CITY OF VANCOUVER  
COMMUNITY SERVICES GROUP

DEVELOPMENT PERMIT STAFF COMMITTEE REPORT  
JUNE 20, 2012

1545 WEST 8<sup>TH</sup> AVENUE (COMPLETE APPLICATION)  
DE415620 - ZONE C-3A

**DEVELOPMENT PERMIT STAFF COMMITTEE RECOMMENDATION: APPROVE**

PLAN  
LEVEL 1

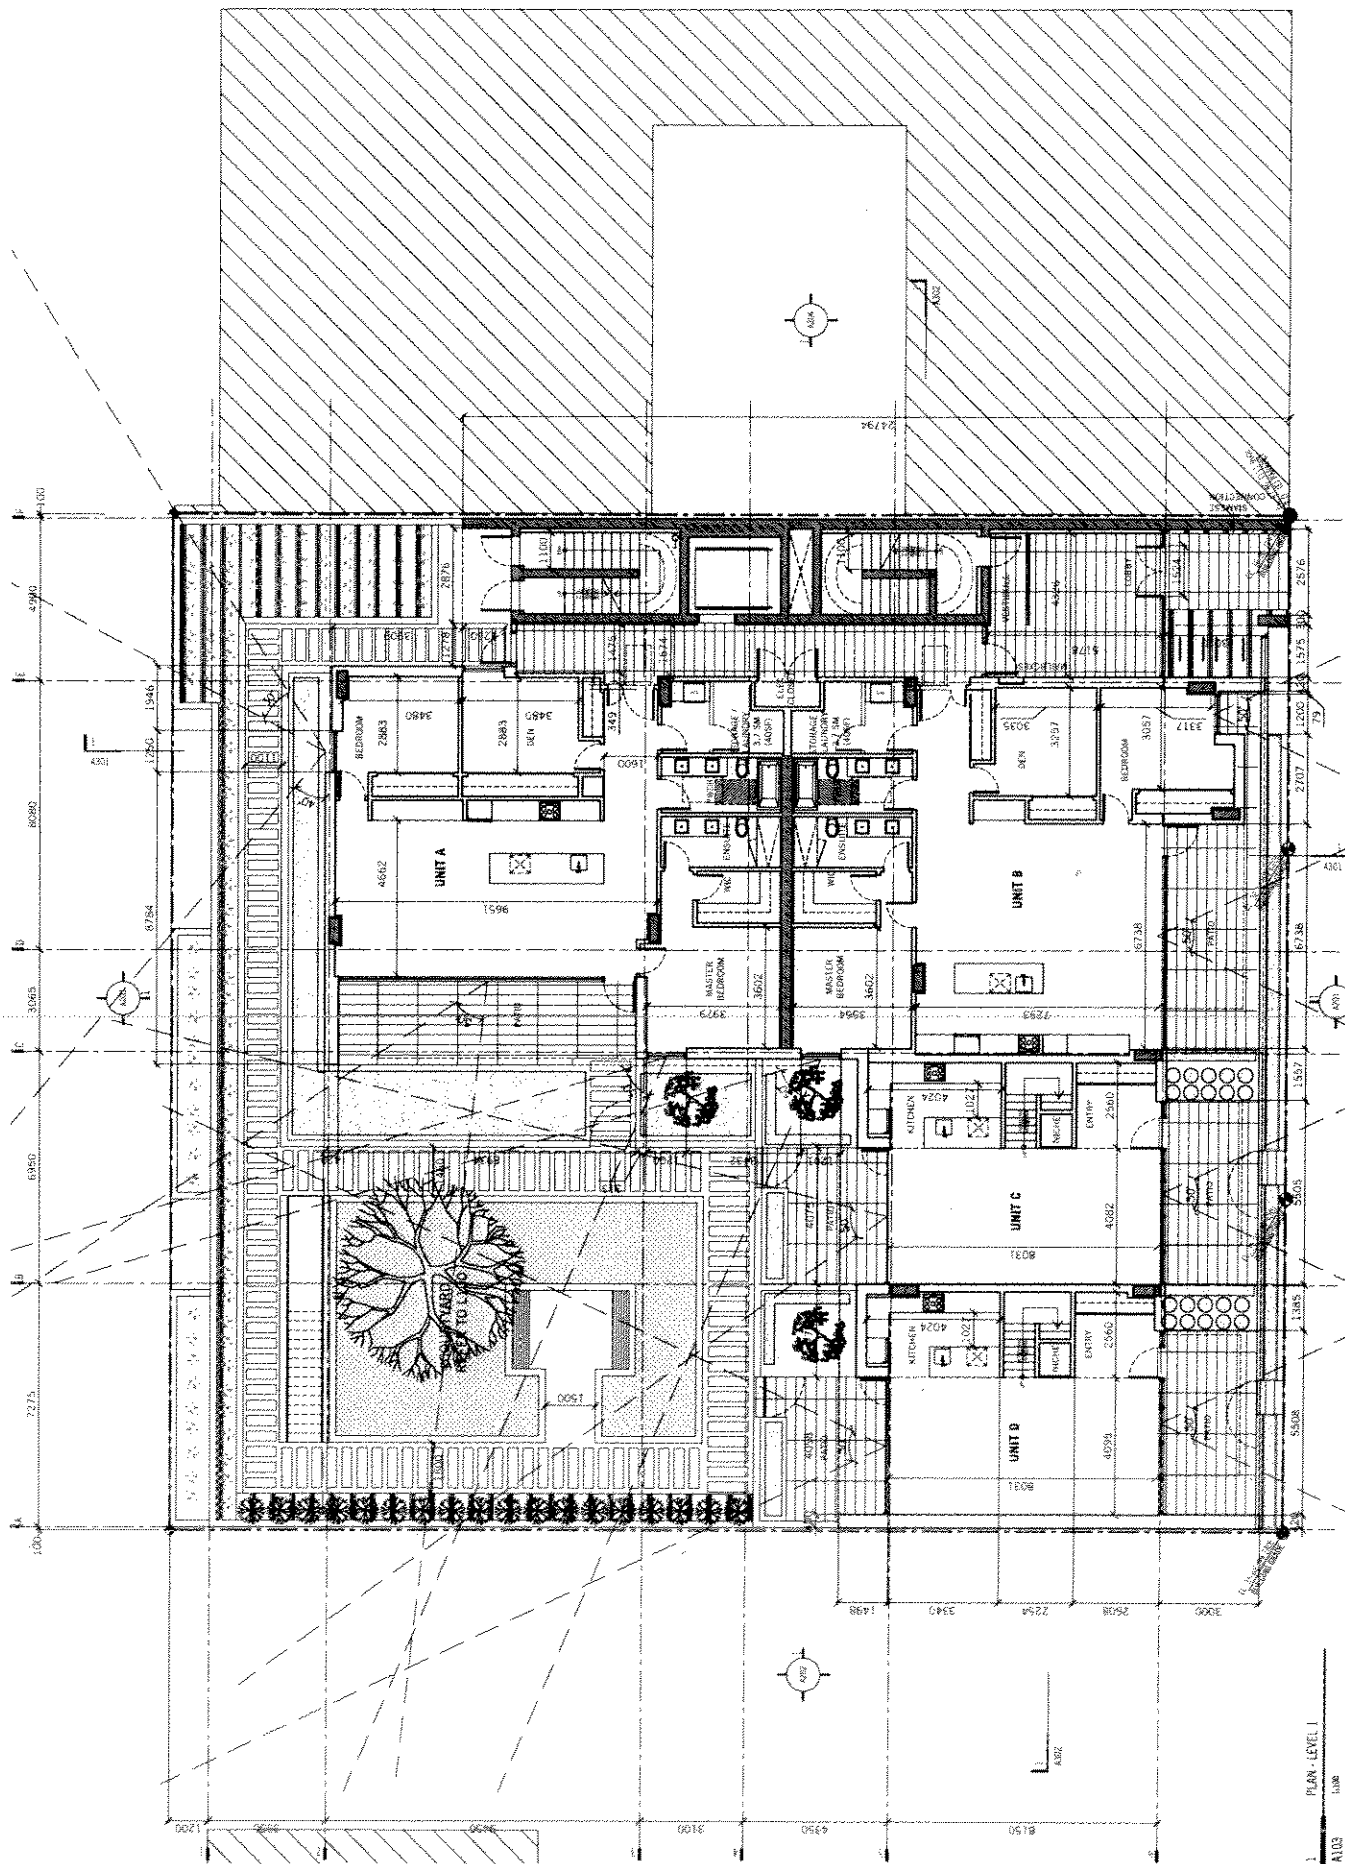
- 1.3.2 modifications to the windows and/or landscape screening to improve visual separation of the master bedroom, unit "B", ground floor level, from the adjacent neighbour's patio and the north bedroom, unit "A", ground floor level, from the common outdoor circulation path; and

- 1.3.3 a window for the den of the unit "B", ground level.

**Note to Applicant:** All inhabitable rooms to have direct access to natural light.

PLAN - LEVEL 4, 5, 6, 7  
A106 1/32

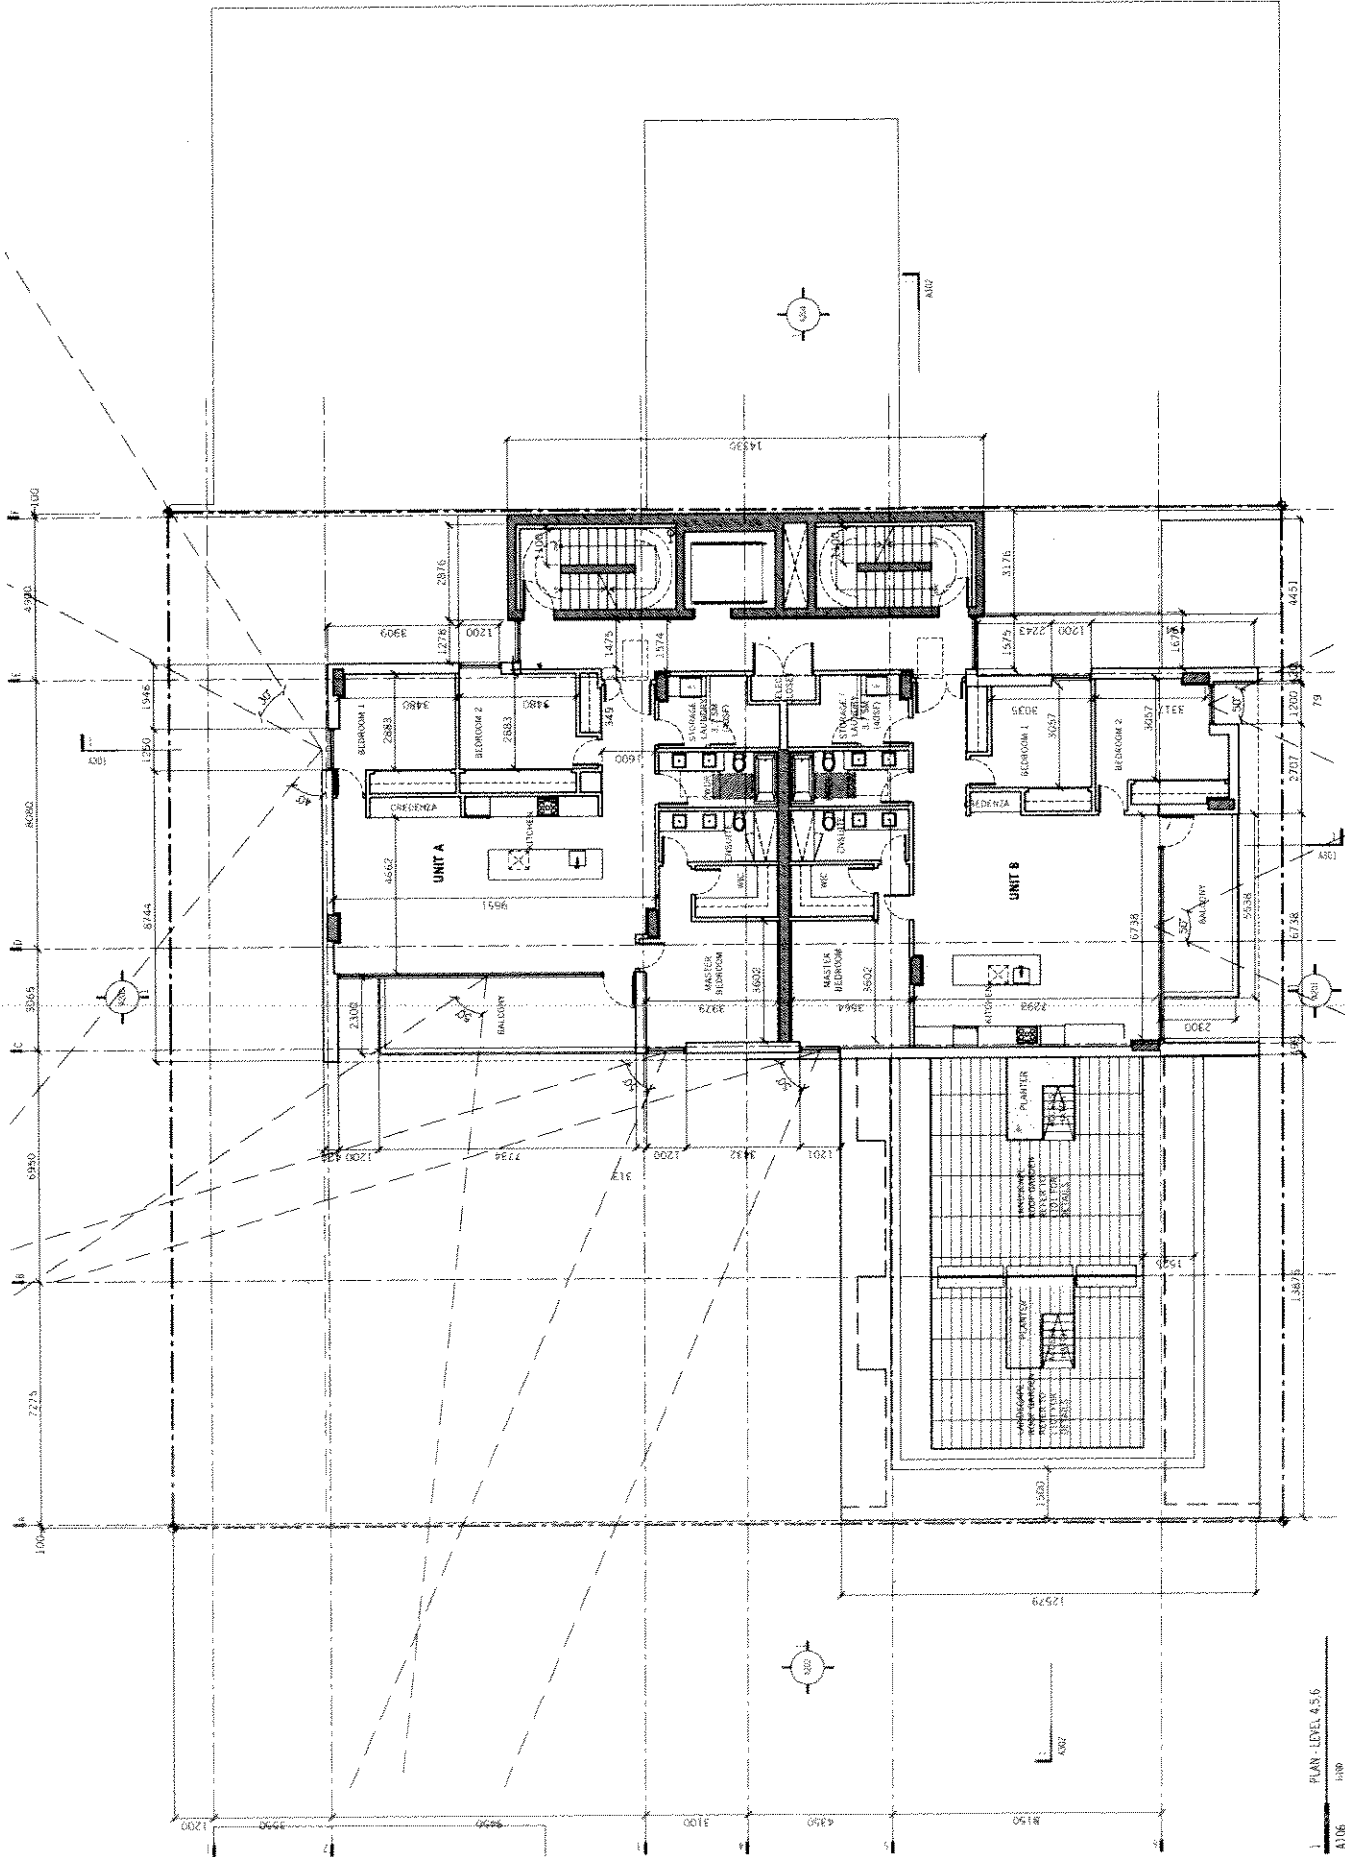
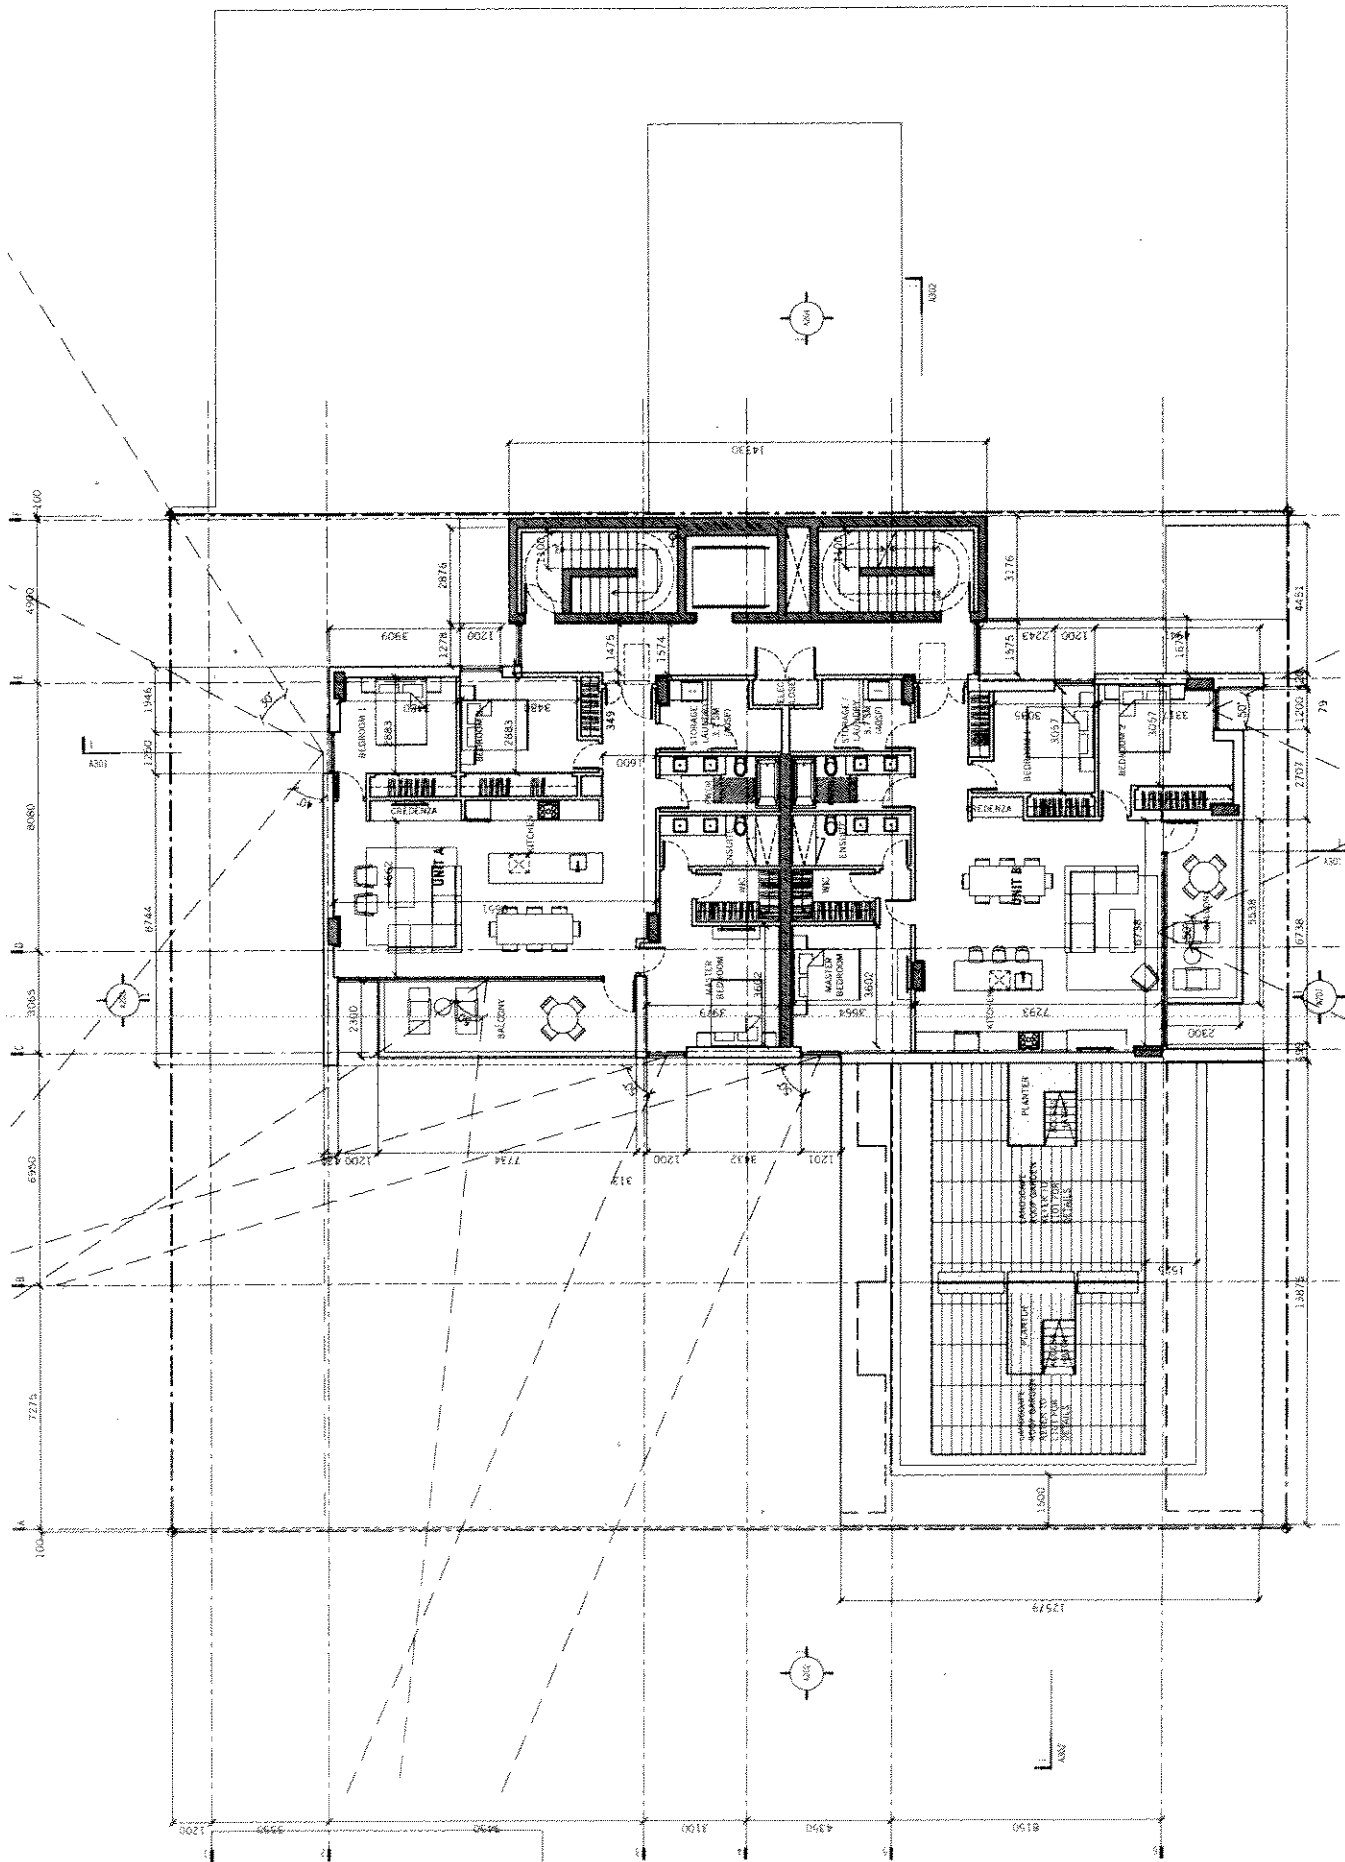
- 1.3.1 windows for the kitchen area of units "B", fourth to eight floor levels;

**Note to Applicant:** To achieve enhanced day lighting and ventilation. The windows are to be well integrated with the composition of the west elevation.

PLAN - ROOF  
A108

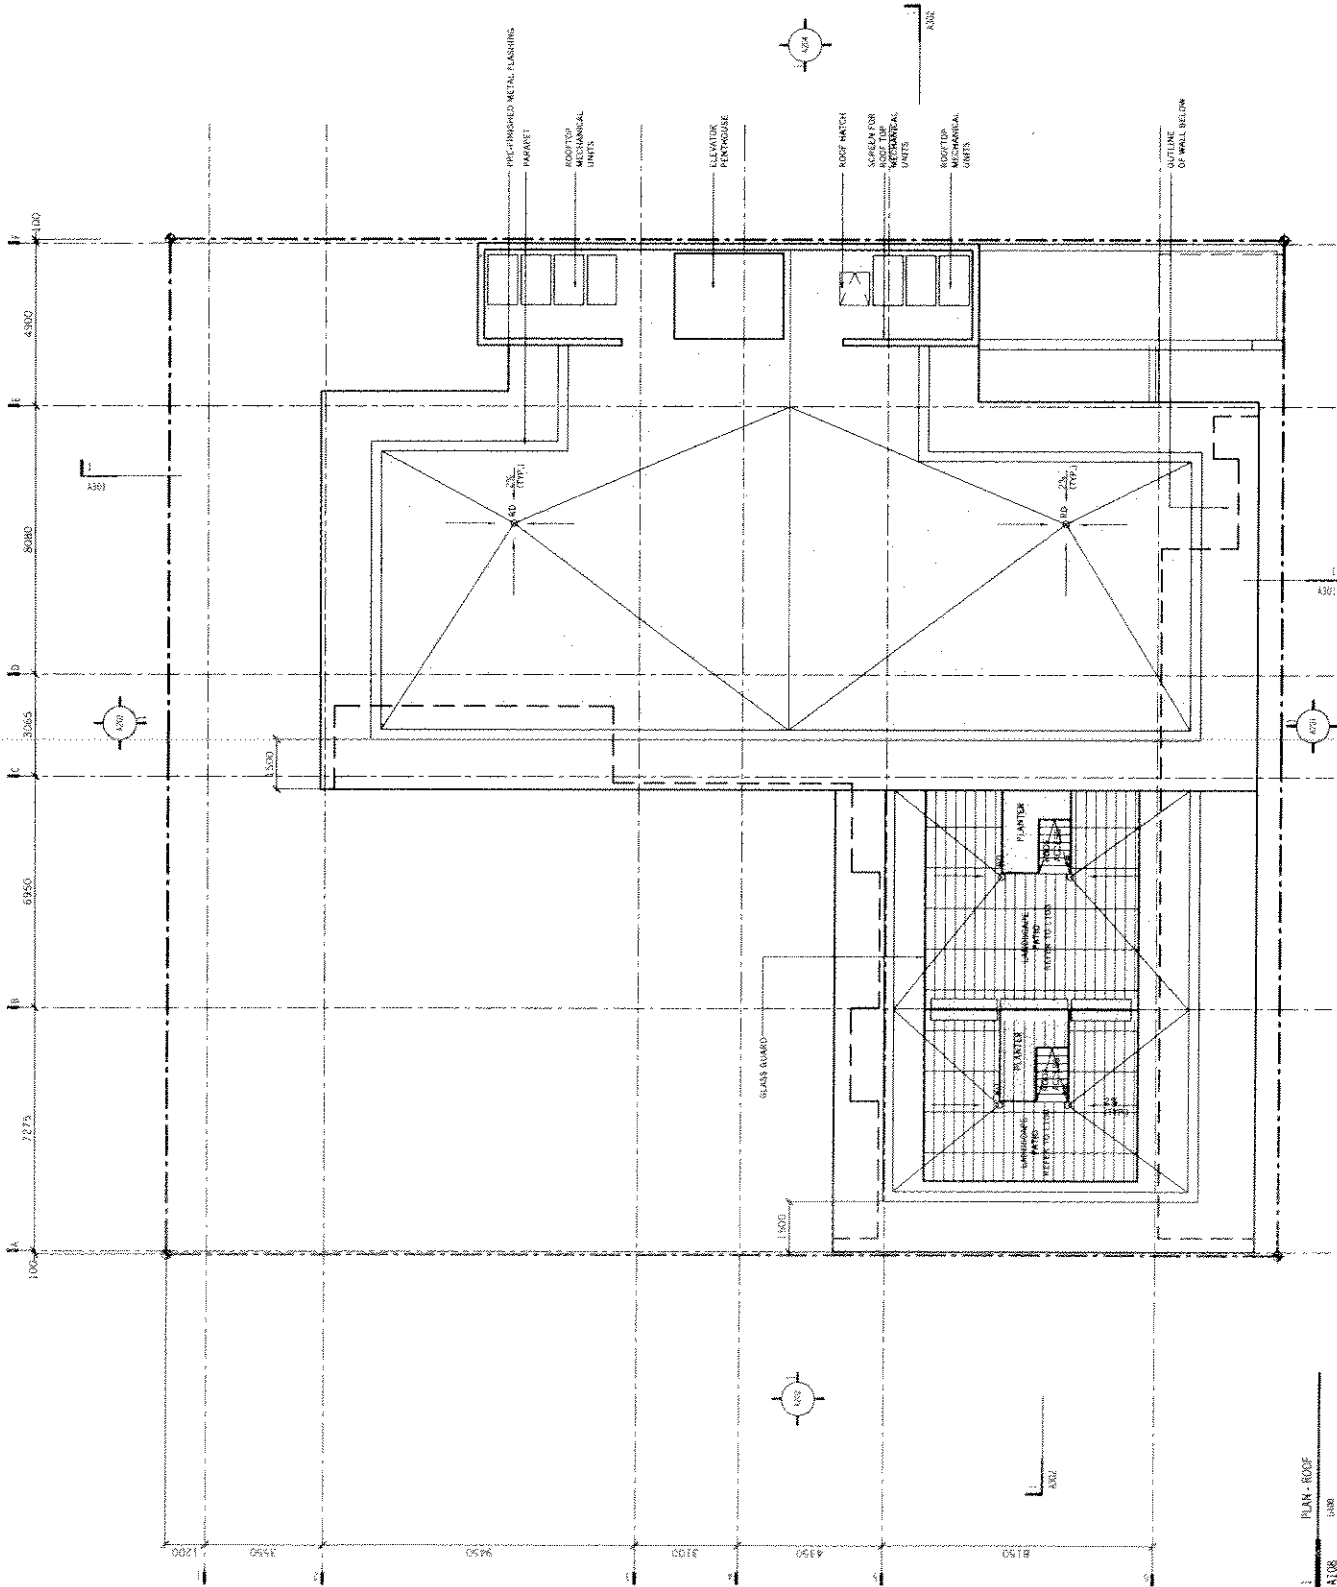
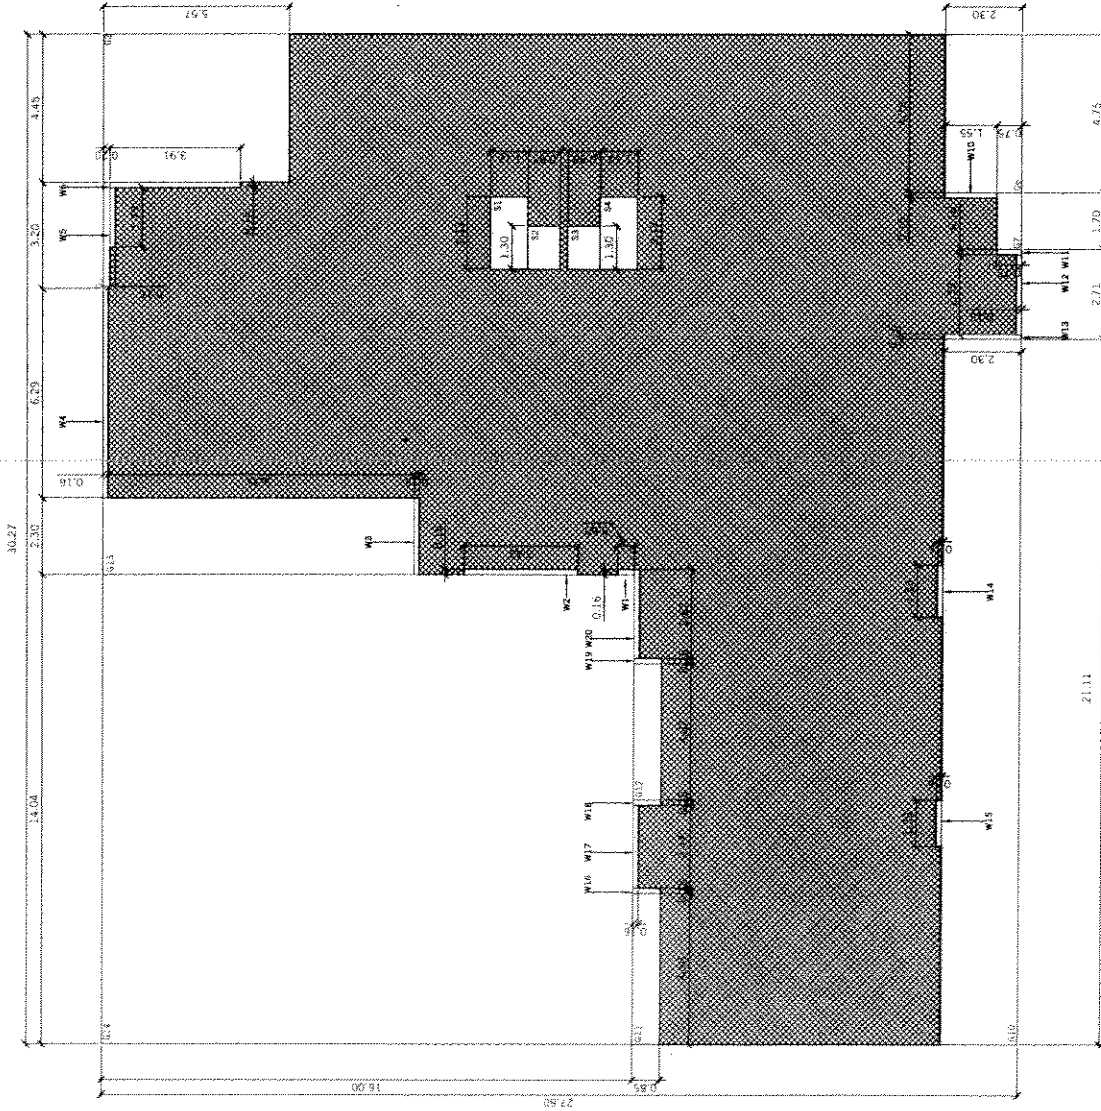
- 1.2 design development to address overlook of the upper roof level from adjacent buildings, providing a pleasing and visually interesting roofscape;

**Note to Applicant:** Through patterning and material variety provide a roofscape that is pleasant to look upon. Consider an extensive or intensive green roof. Roof access should be restricted for maintenance purposes and accessible by stair only. No additional height beyond the current proposal is permitted.
